Document Management Number 8TEQJ-0591(1)

# Component Change Notice

Dip slide switch: CFS series, CFP series.

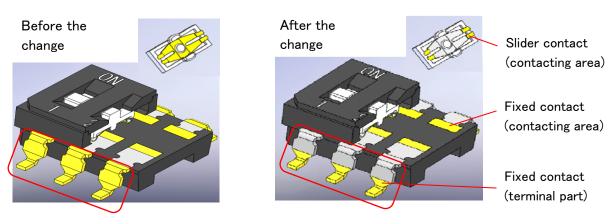
We are writing to inform you that we are planning to change the plating and material of the slide switches supplied to you as follows.

| Component name | Details         | Before the change              | After the change                        |
|----------------|-----------------|--------------------------------|---|
| Slider contact | Au plating area | The whole contacting side      | Contacting area only                    |
| Fixed contact  | Au plating area | Faces of both sides            | Contacting area and soldering area only |
|                | Metal material  | Copper alloy (phosphor bronze) | Copper alloy (brass)                    |

\* The drawing is for CFS series. The CFP series share the same contact structure with CFS series. The slider contact and fixed contact will change at the same time.

The part marked out in the red box of the drawing above: appearance color of the terminal part of the fixed contacts differs.
